# Commonwealth Edison Company

COMMONWEALTH EDISON COMPANY

Response to ACRS Concerns

Furnace Sensitized Stainless Steel Components

CORE SPRAY CONFIGURATION

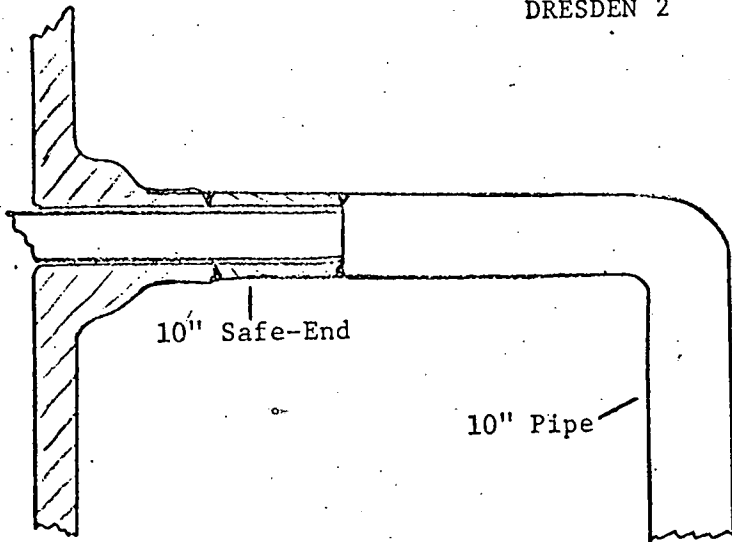
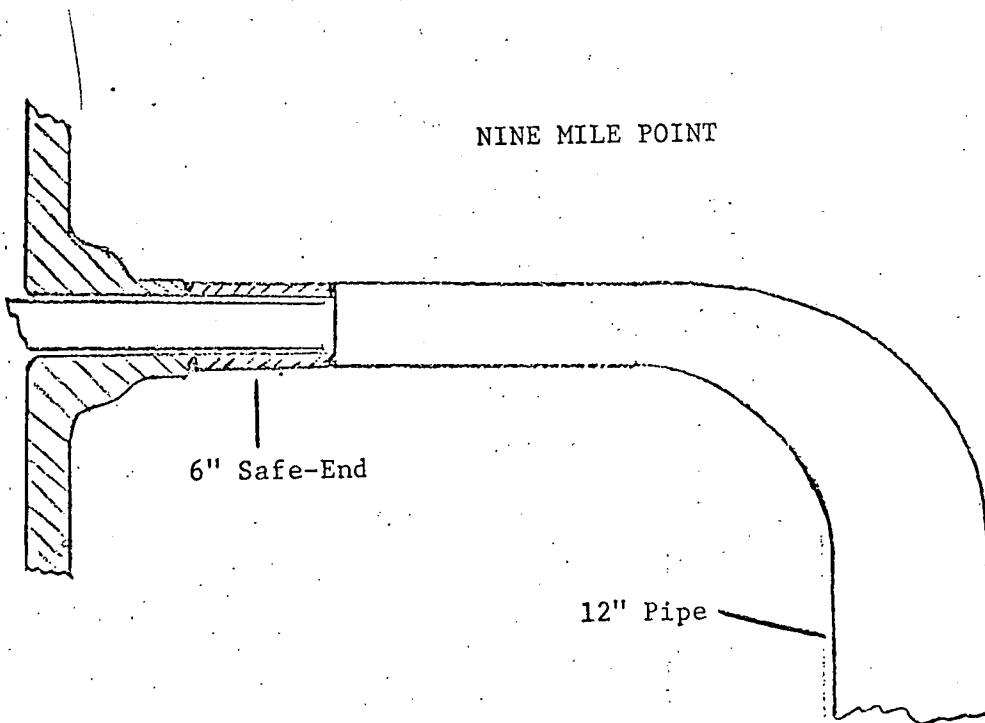
- 8 - Discuss and compare the differences between Dresden 2 and Nine-Mile Point with respect to cleaning procedures (including PT, stresses, fill, flush and drain procedures, heat treatment, oxygen and chloride limits, layout, and materials) to the extent information is available.

- A. THERMAL SLEEVE DESIGN.
- B. NOZZLE SIZE VS PIPE SIZE (CORE SPRAY).
- C. DIFFERENT VESSEL MANUFACTURER.
- D. CLEANLINESS AND CLEANING PROCEDURES THROUGHOUT  
VESSEL ERECTION PERIOD.
- E. 316 SAFE-END AT DRESDEN VS 304 AT NMP.

The basic difference between Dresden 2 and Nine Mile Point relative to the above items is as follows:
